**STAFF RECOMMENDATION**  
**114 Lindsley Park Drive**  
**December 19, 2018**

**Application:** New Construction—Infill  
**District:** Lockeland Springs-East End Neighborhood Conservation Zoning Overlay  
**Council District:** 06  
**Map and Parcel Number:** 08309045000  
**Applicant:** Mitch Hodge  
**Project Lead:** Melissa Sajid, [melissa.sajid@nashville.gov](mailto:melissa.sajid@nashville.gov)

**Description of Project:** Application is two construct a detached duplex on the property with one unit fronting Lindsley Park Drive and the other fronting South 15<sup>th</sup> Street.

104 Lindsley Park Drive – non-contributing (infill approved by MHZC in 2009)

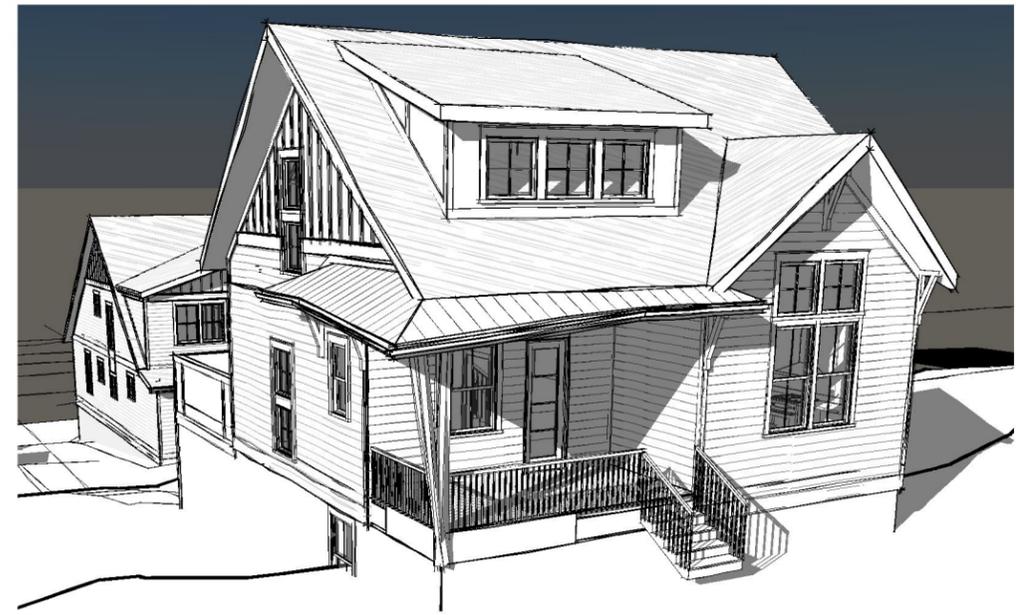
The infill facing South 15<sup>th</sup> Street will have an overall height of approximately thirty-seven feet, three inches (37'-3") at the front, which includes a foundation height of approximately five feet, six inches (5'-6"). Given the change in grade, the house will be approximately twenty-five feet (25') tall at the rear, without an exposed foundation. Staff finds that overall height and one and one-half story form of the house are appropriate as there is no historic context on this block of South 15<sup>th</sup> Street. The only other house on this block is 102 South 15<sup>th</sup> Street, which was constructed c. 1955 and does not contribute to the character of the neighborhood. The context on the same side of the street as the proposed infill includes the rear of the non-contributing house at 104 Lindsley Park Drive, which is three stories along South 15<sup>th</sup> Street (Figure 4).

SITE PLAN, VIEWS

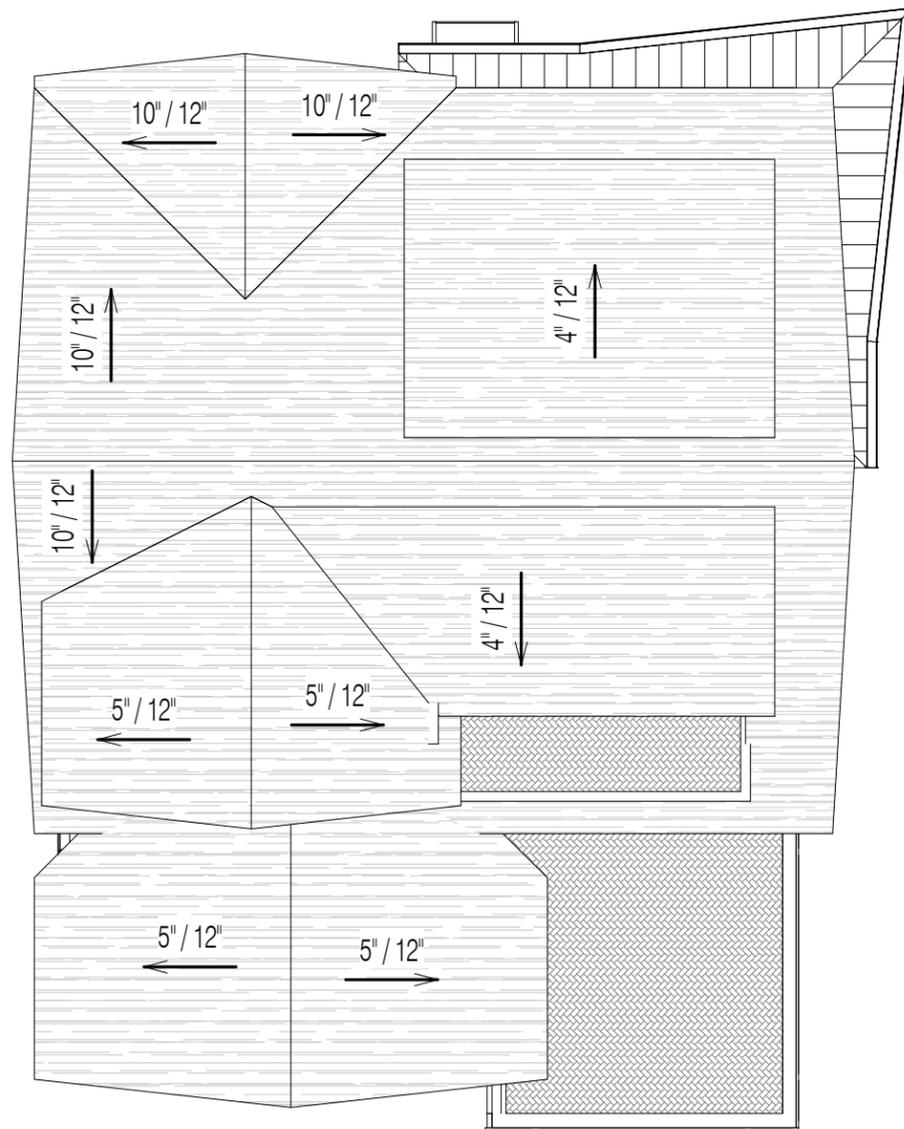
The proposed houses will meet all base zoning setbacks. Both houses will meet the minimum front setback of twenty feet (20'), which is appropriate as the abutting lots provide no historic context for a front setback. The infills will be a minimum of five feet (5') from the side property lines. As this is a double frontage lot, there is no rear setback. The two houses will be spaced approximately thirty-three feet (33') apart. The project meets Section II.B.1.c.

The plan also includes an attached garage for the Lindsley Park Drive unit that is accessed from a proposed driveway off South 15<sup>th</sup> Street at the rear. The attached garage is located at basement level, which meets the criteria in the design guidelines for when attached garages may be appropriate. The South 15<sup>th</sup> Street unit incorporates an attached carport that is also accessed from the proposed driveway off South 15<sup>th</sup> Street. While the attached carport is not located at basement level, staff finds that it could be appropriate in this case given the steep topography on the lot.

Appurtenances & Utilities: The project will have access via South 15<sup>th</sup> Street from a shared driveway. The locations of the HVAC and other utilities were not noted on the plans. Staff asks that the HVAC be located on the rear façade, or on a side façade beyond the midpoint of the house. Staff also recommends that both units incorporate walkways that connect the front porches to the street. With the conditions that the HVAC be located on the rear façade, or on a side façade beyond the midpoint of the house and that the plan incorporate walkways connecting the front porches to the street, staff finds that the project meets Section II.B.1. i.

1. The finished floor height shall be consistent with the finished floor heights of the adjacent historic houses, to be verified by MHZC staff in the field;
2. Staff shall approve the final details, dimensions and materials of foundation, roof color, trim, windows, doors, garage door, porch steps, porch floor, porch railing, porch posts, walkway, and driveway material prior to purchase and installation;
3. The siding reveal shall not exceed five inches (5");
4. and that staff approve the materials of the foundation, roof color, trim, windows, doors, garage door, porch steps, porch floor, porch railing, porch posts, walkway, and driveway prior to purchase and installation
5. The site plan shall incorporate a walkway for each unit that connects the front porch to the street; and
6. The HVAC shall be located behind the house or on either side, beyond the midpoint of the house.

**LINDSLEY PARK DRIVE PLANS**  
**2**  
 PROJECT 1840  
 DATE 12.03.18  
 rev

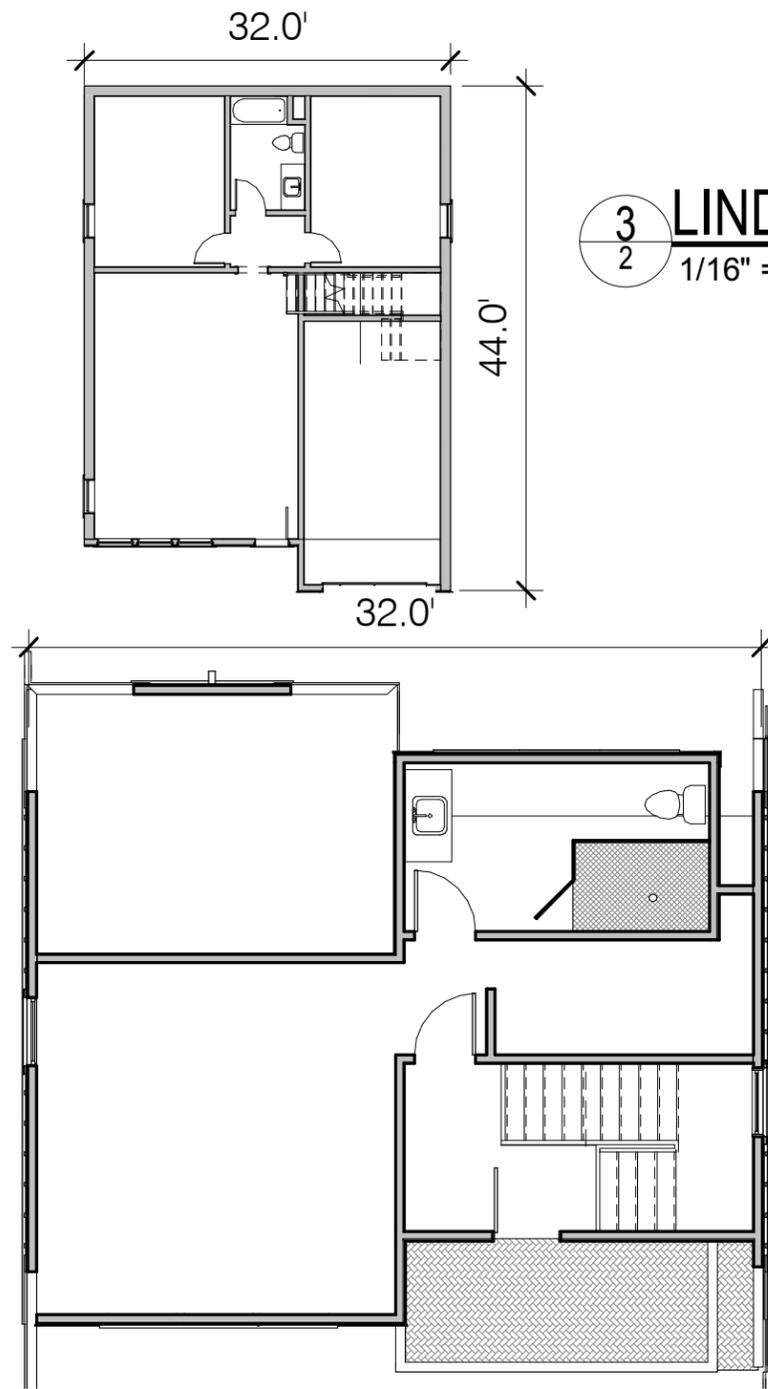
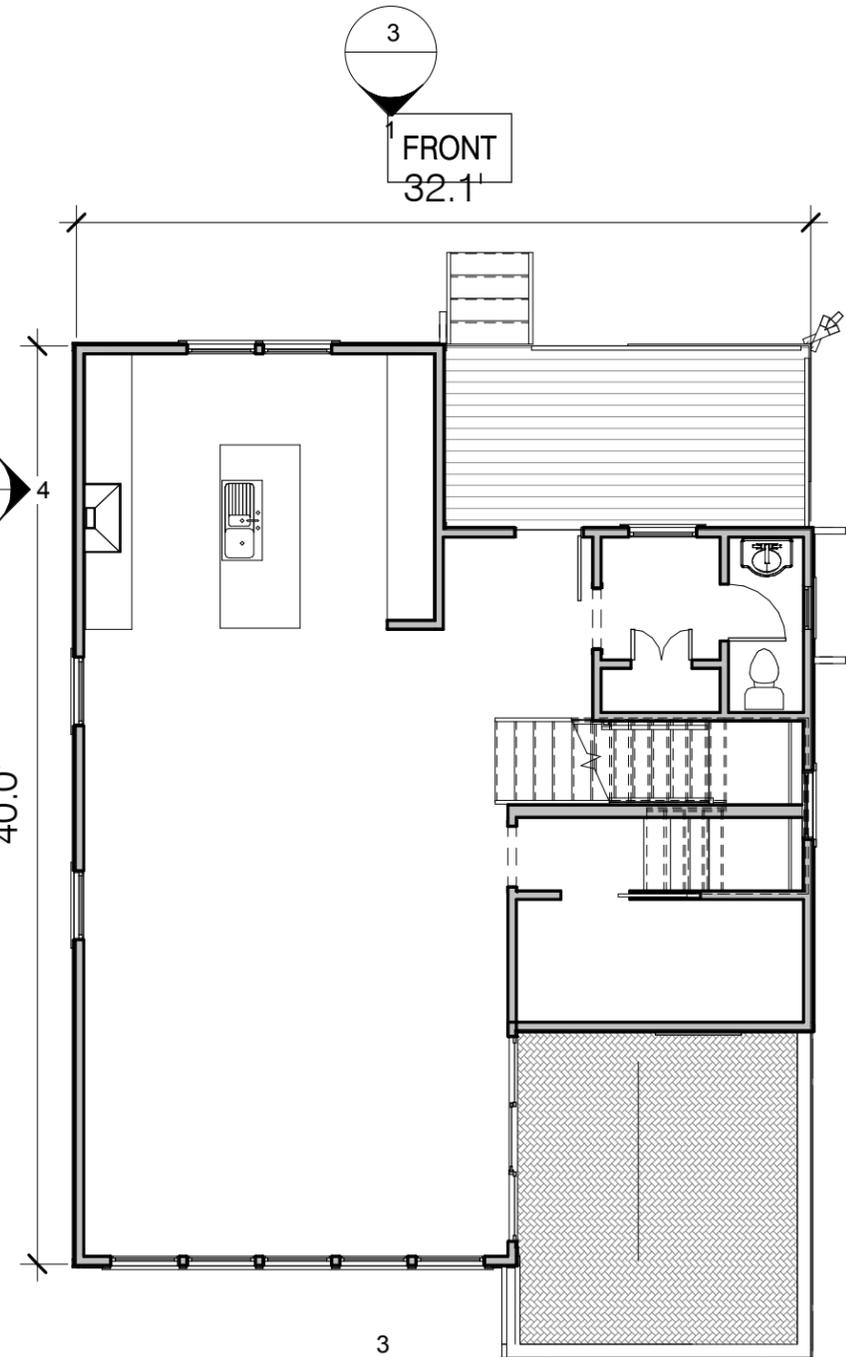
Height & Scale: Both proposed houses will be one and one-half stories at their respective fronts. The Lindsley Park Drive house will be three stories at the rear while the South 15<sup>th</sup> Street house will have a taller foundation at the front due to the steep grade of the lot. The overall height of the building facing Lindsley Park Drive is approximately twenty-eight feet (28') from the front grade, which is similar to the infill approved by the Commission in May 2017. All of the historic homes on Lindsley Park Drive have the massing of one and one and one-half story homes and are between sixteen and twenty-six feet (16' – 26') tall.

The new infill fronting Lindsley Park Drive will have a width of approximately of thirty-two feet (32’) while the width of the unit fronting South 15<sup>th</sup> Street will be approximately twenty-eight feet (28’) wide. Historic buildings in the immediate vicinity on lots with similar widths range from thirty to thirty-three feet (30’-33’) wide. The narrower width for the 15<sup>th</sup> Street house is appropriate because of the lack of historic context and the height of the proposed building. Staff finds that the proposed building widths are appropriate given the context.

SOUTH 15TH ST PLANS

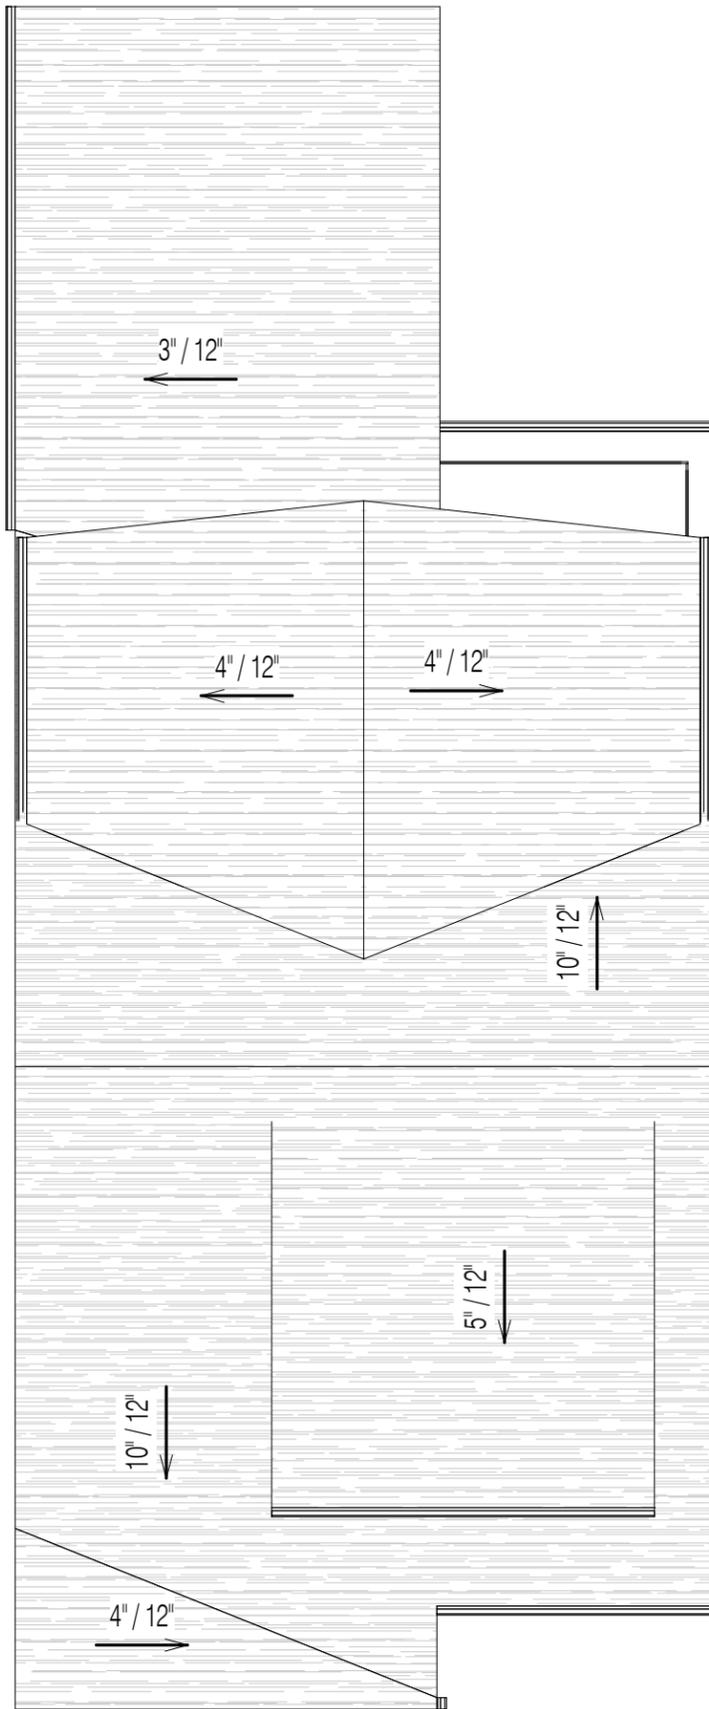
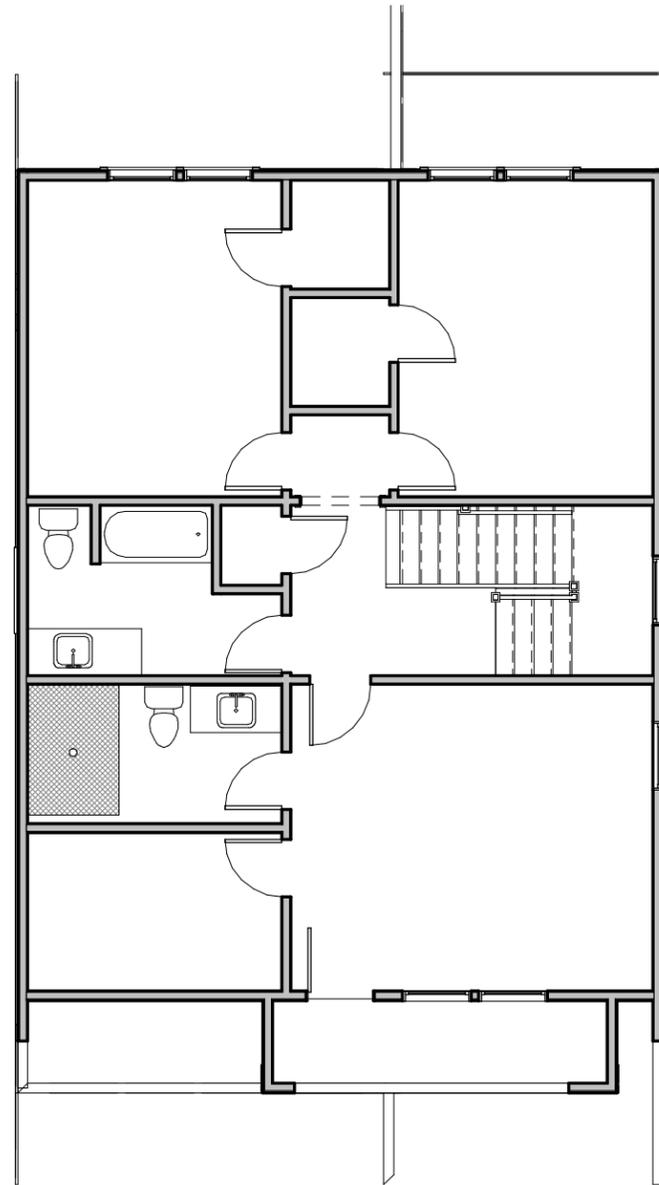
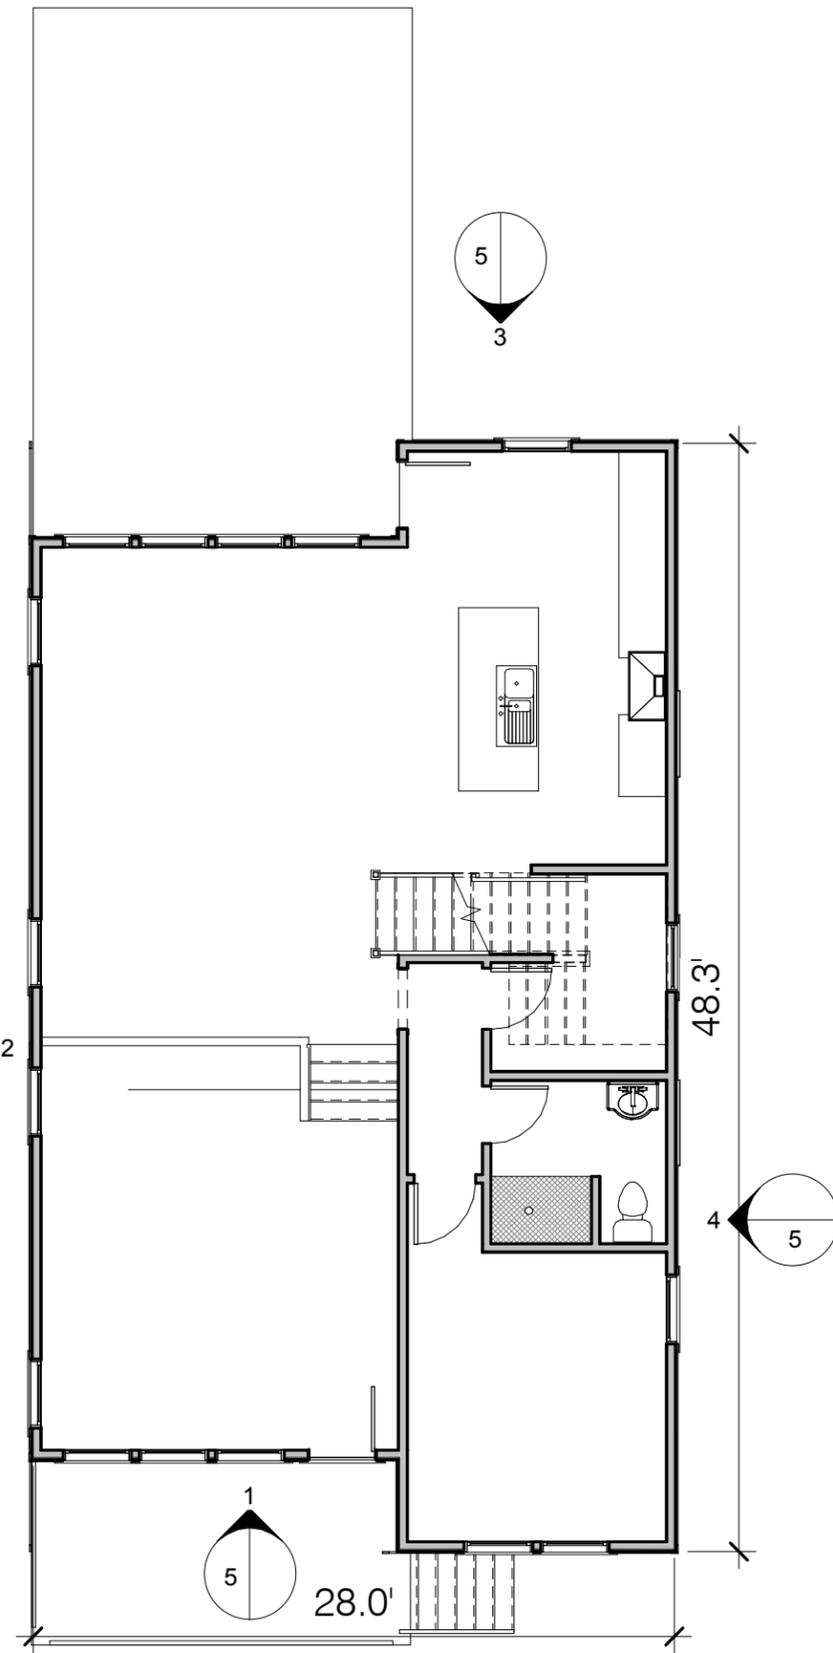
The South 15<sup>th</sup> Street unit will have a side-gabled roof form with a 10/12 slope. The plan includes a shed dormer with a slope of 5/12 on the front façade that sets in four feet (4’) from the wall below. The front dormer includes a balcony that is located fully under the dormer roof. The Commission has approved similar designs for balconies within dormers on infill. The rear elevation includes a gabled dormer with a 4/12 pitch on the rear. The eave of the portion of the roof the covers the front porch has a pitch of 4/12 and is at an angle. While the angle is not typically seen on historic homes, staff finds that it is

SOUTH 15TH ST  
ELEVATIONS

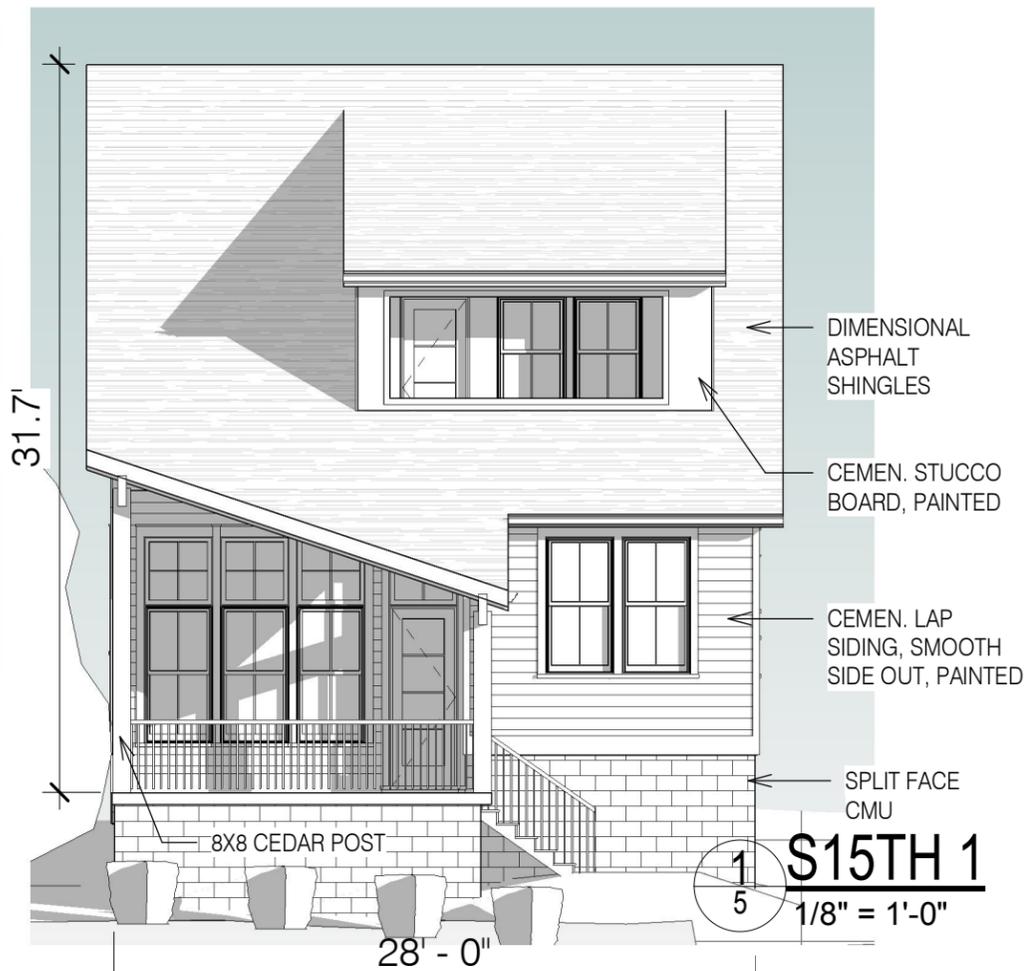
appropriate on infill as a modern interpretation that helps to distinguish the infill from historic homes in the neighborhood. Staff finds that the South 15<sup>th</sup> Street unit's roof form meets the design guidelines. Staff finds that the roof form and pitches are compatible with the historic context and meet Section II.B.1.e.

Proportion and Rhythm of Openings: Most of the windows on the proposed infills are generally twice as tall as they are wide, thereby meeting the historic proportions of openings. The plan for the South 15<sup>th</sup> Street unit includes several smaller square windows. Staff, however, finds that these windows could be appropriate since they are not located on the front or side façades near the front. In addition, they are compatible with the more modern design of the infill. There are no large expanses of wall space without a window or door opening. Staff finds the project's proportion and rhythm of openings to meet Section II.B.1.g.
